DATE: February 14, 2024

<u>Certificate of Appropriateness Request:</u>	H-14-22
<u>Applicant:</u>	Jim Potter/Old Towne Development
<u>Location of Subject Property:</u>	74, 76, 78 Cabarrus Ave W
<u>PIN:</u>	5620-87-0418
<u>Staff Report Prepared by:</u>	Autumn James, AICP - Planning & Development Manager

- On April 13, 2022, Jim Potter with Old Towne Development applied for a Certificate of Appropriateness under Concord Development Ordinance (CDO) §9.8 to construct three (3), two-story units with detached two (2) car garages.

1 PRELIMINARY SITE PLAN

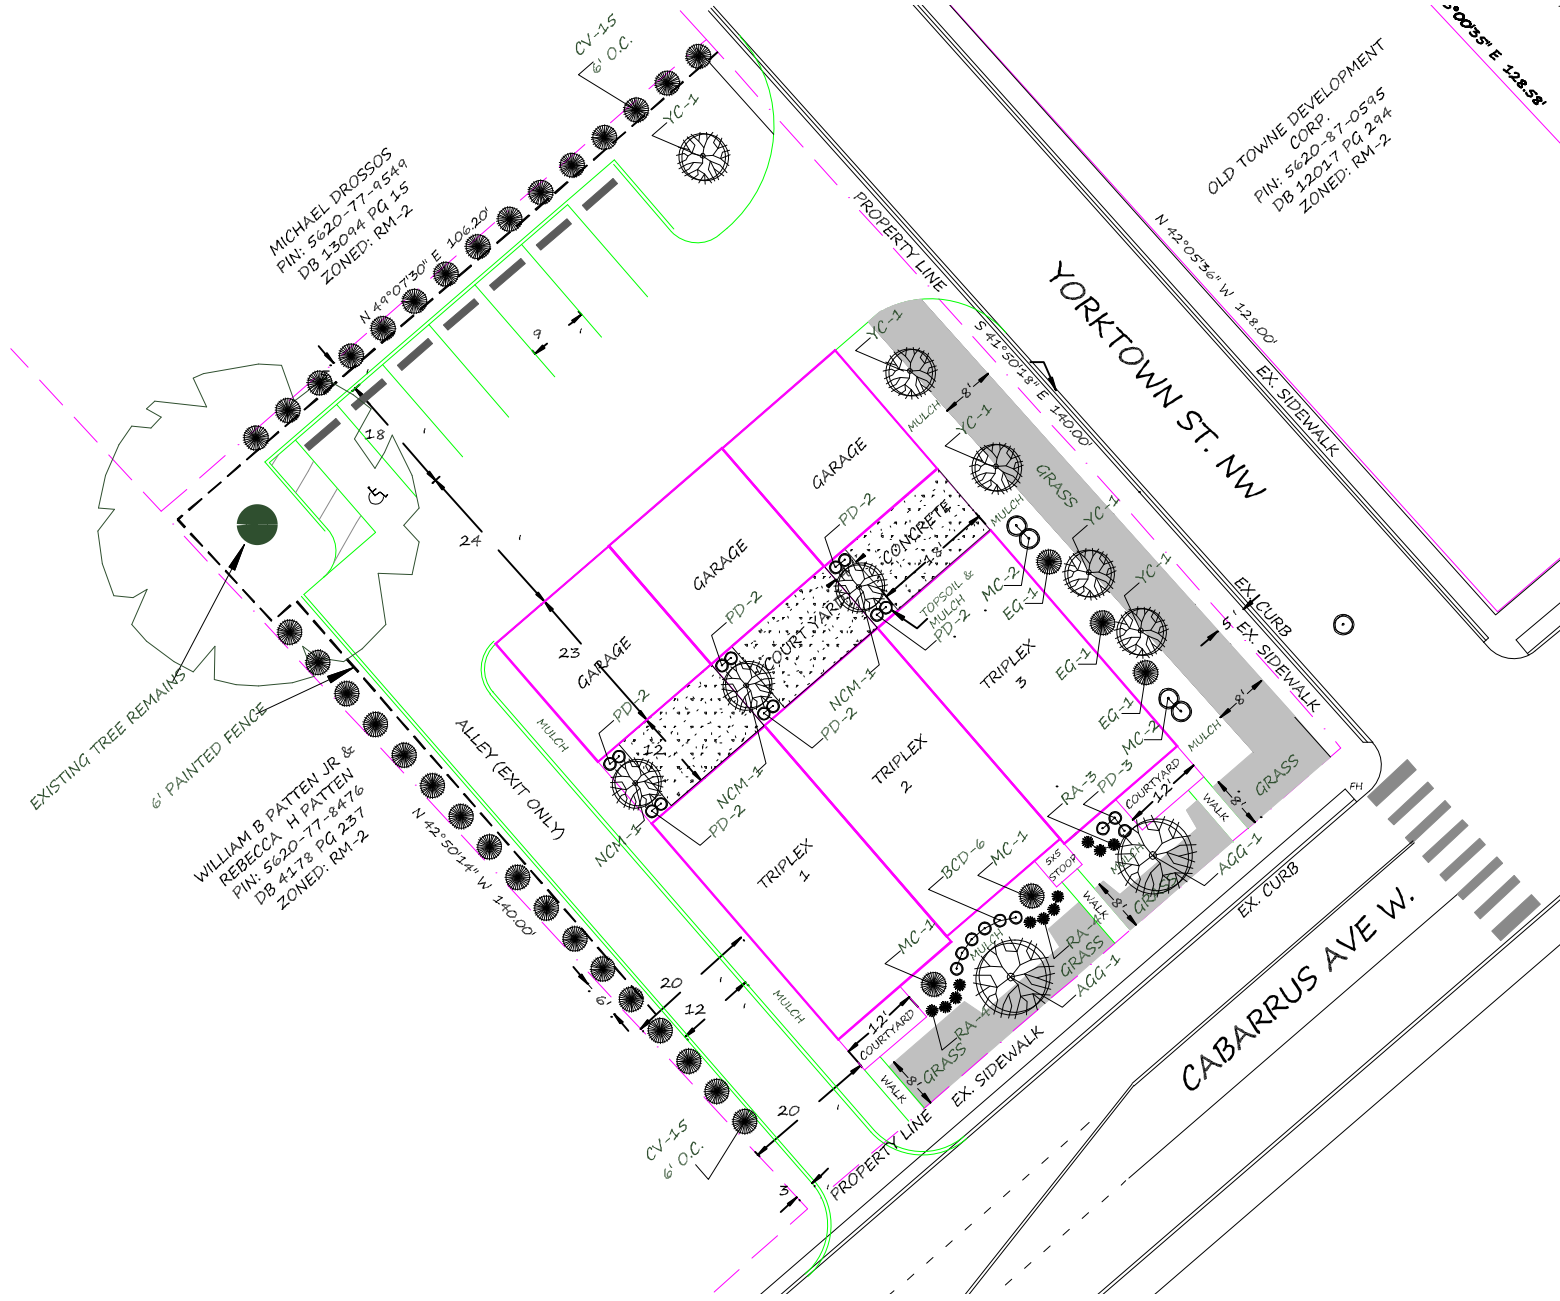
- On January 10, 2024, this case was continued by the Historic Preservation Commission (HPC) and continued to the February meeting in order to receive the following information: an updated site plan (Exhibit B), updated landscaping plan (Exhibit C), an updated exterior color scheme (Exhibit D), and updated elevations (Exhibit E).

they could be replaced. Commissioner Underwood asked about the fence and if there has to be some landscaping to have that within two years to soften it. She said she does not see that. Ms. Wallis stated that the landscaping was not proposed. Chair Isenhour asked if the landscaping needs to be completed within 2 years is in the handbook. Ms. Wallis pulled up the information about fences from the Historic Handbook and read it to the Commission. It stated that portions of rear yard fences that face the street should be landscaped with shrubs and trees of a planting size that will fully hide the fence from the street within two years. Size, type and growth habits of plant materials to screen rear yard fences that face the street should be submitted at time of application. Chair Isenhour stated that there was not a landscaping plan submitted by Mr. Potter. Chair Isenhour also stated that if this needs to be added then the plans should be resubmitted with additional information. The privacy fence will be on both sides of the house and driveway so it will be visible from Yorktown and the other side would not be.

Exhibit B: Site Plan updated 02/06/24

FRONT ELEVATION

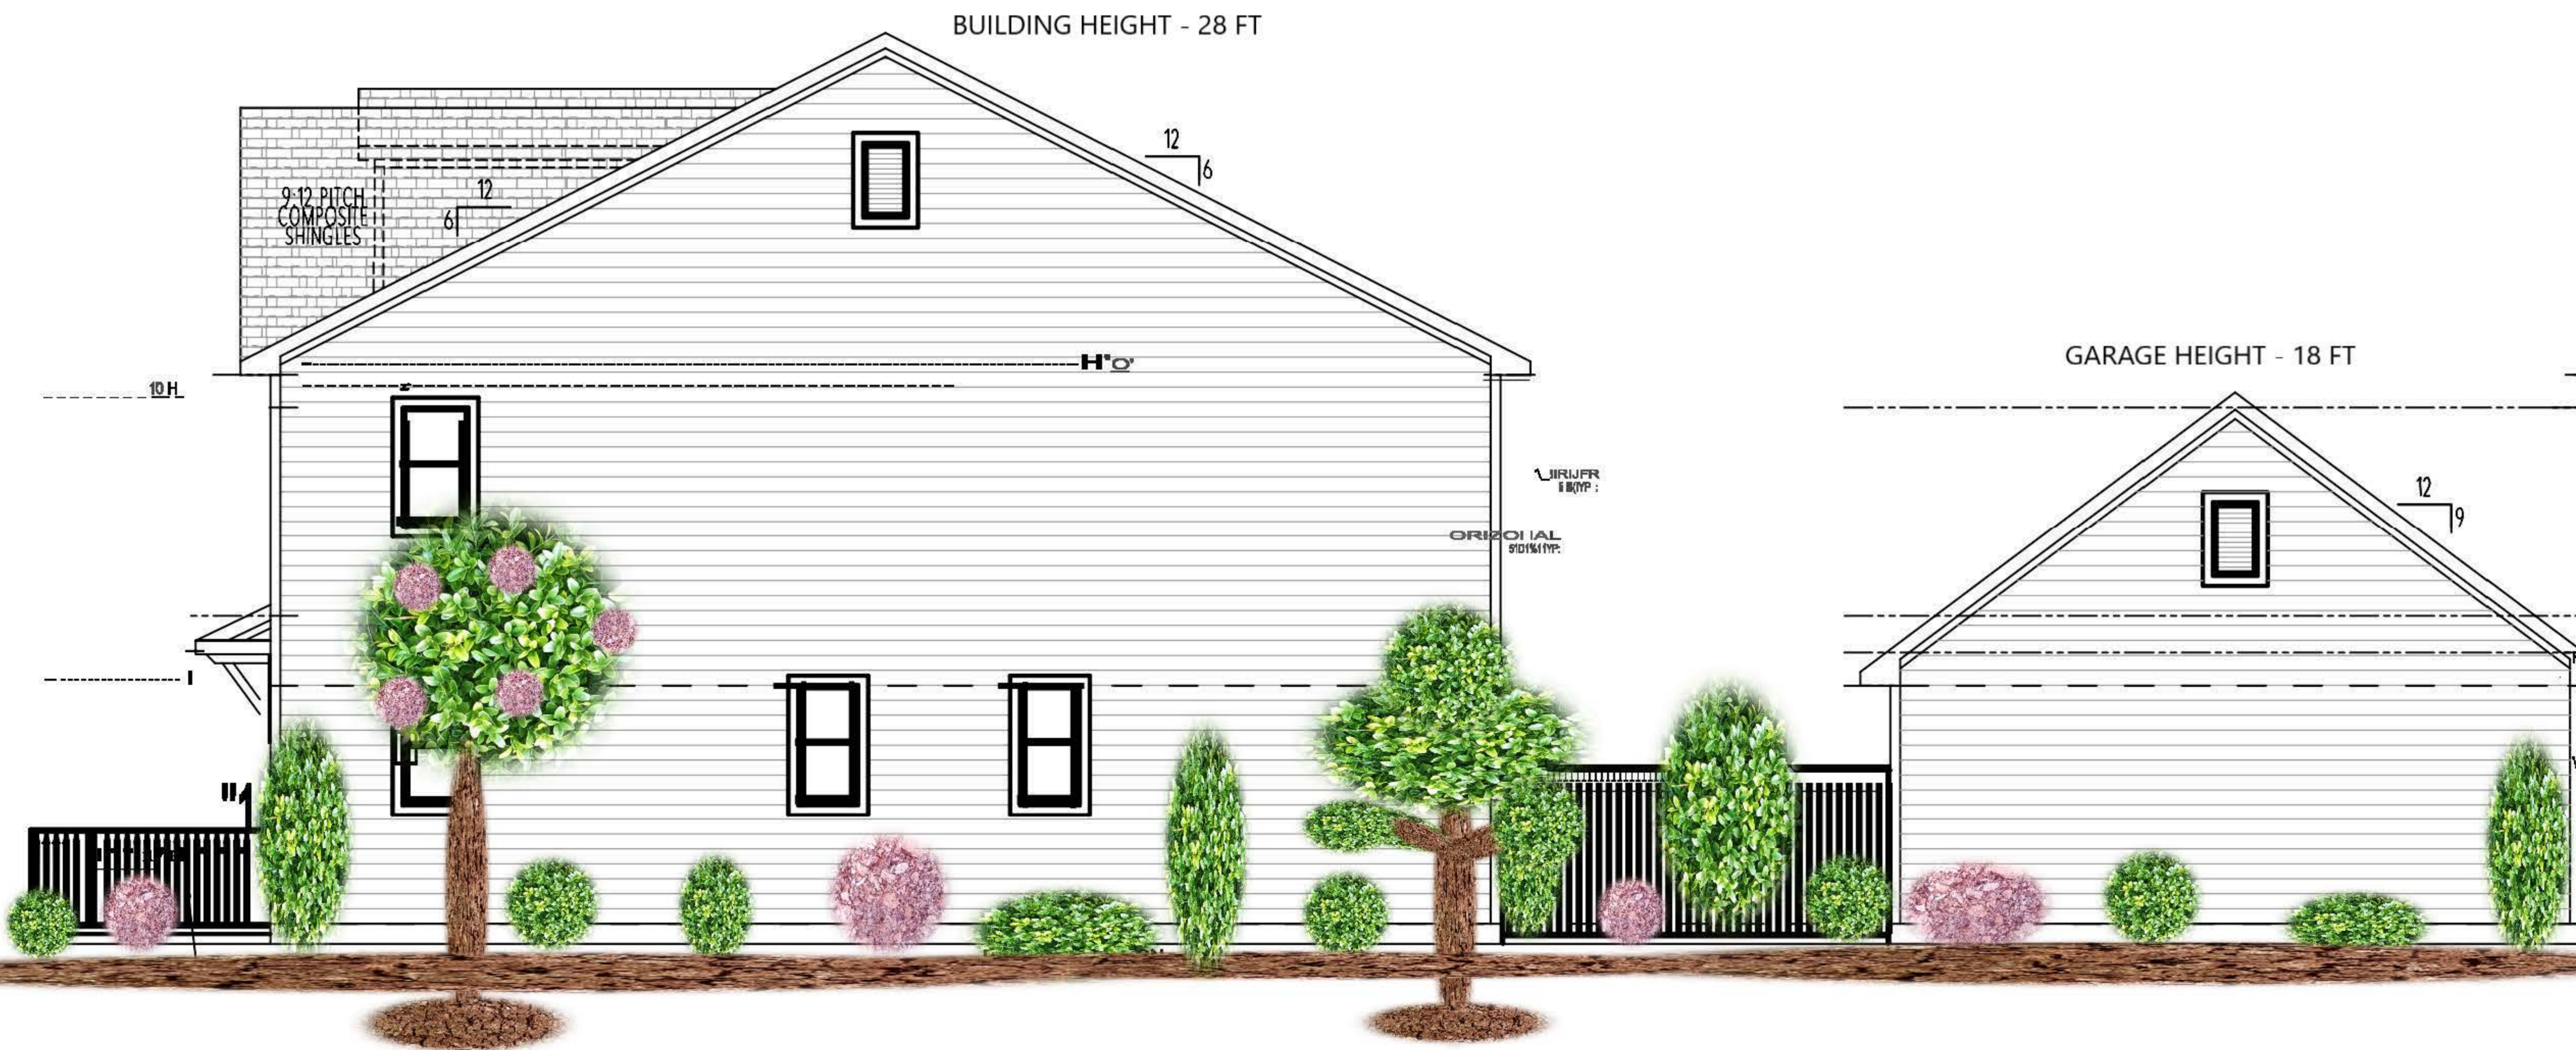
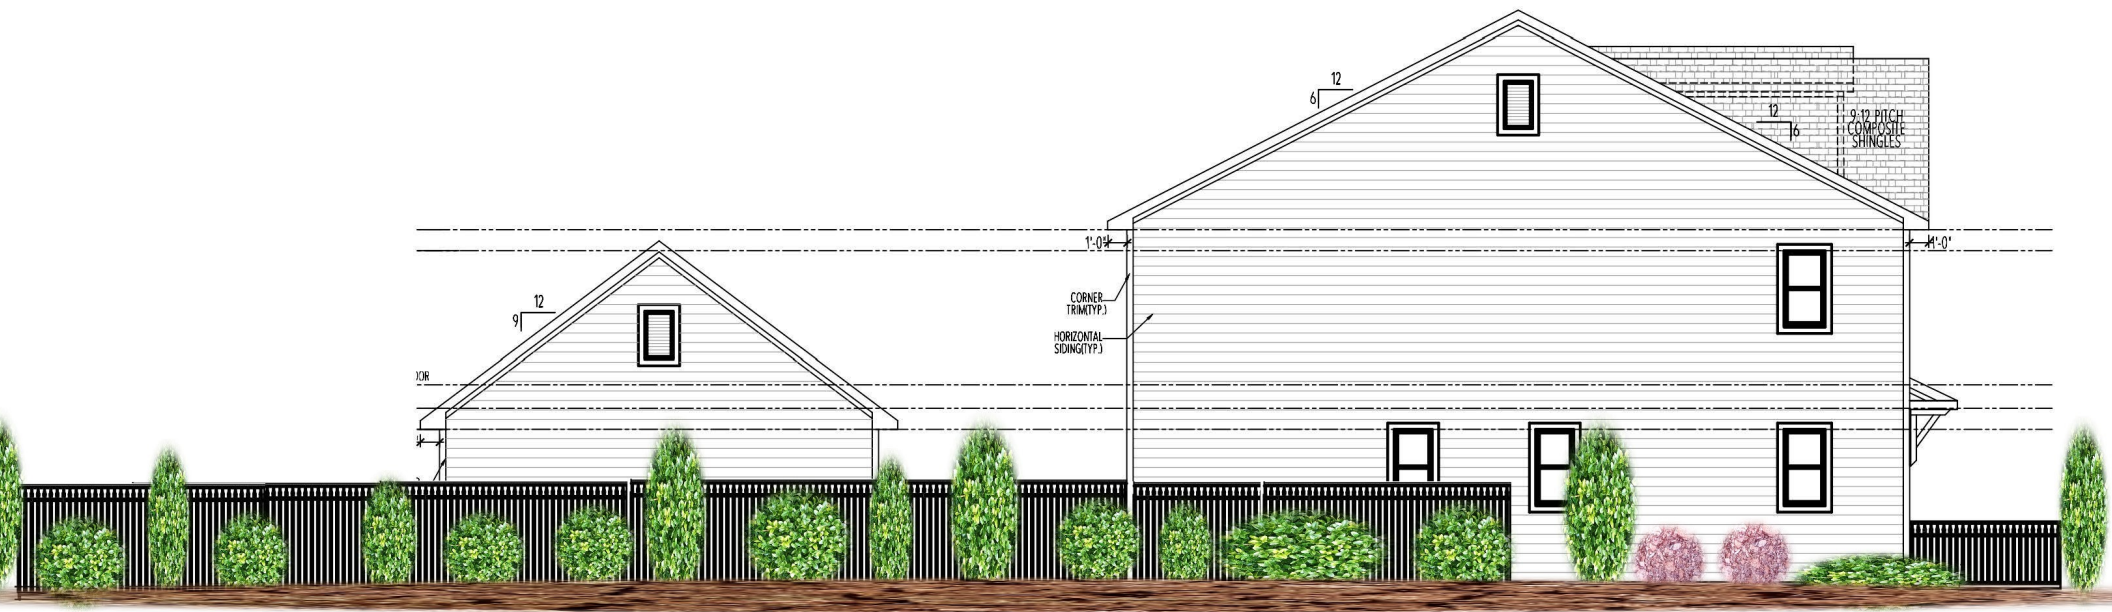
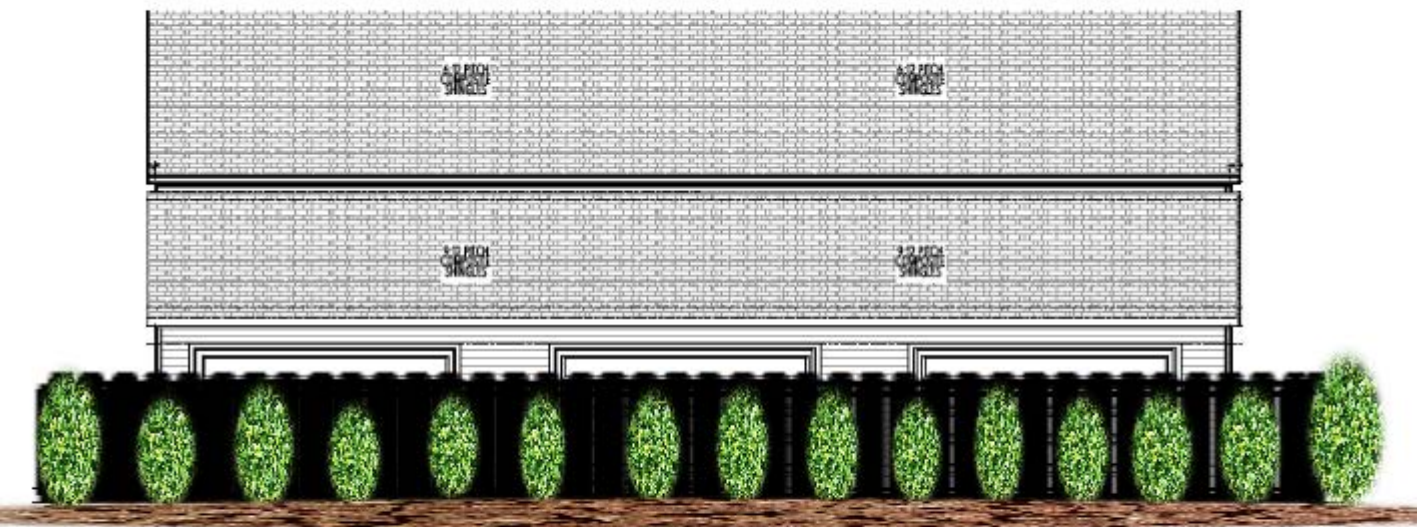
- On November 8, 2023, this case was reviewed by the Historic Preservation Commission (HPC) and continued to the December meeting in order to receive the following information: the front elevation to represent the updated color scheme, a landscaping plan, an indication of the height of the roof on the front elevation, a photograph of the proposed front yard fence indicating the material, and the window material to be changed from aluminum clad to wood (Exhibits F, G).

Exhibit E: Elevations updated 02/04/2024
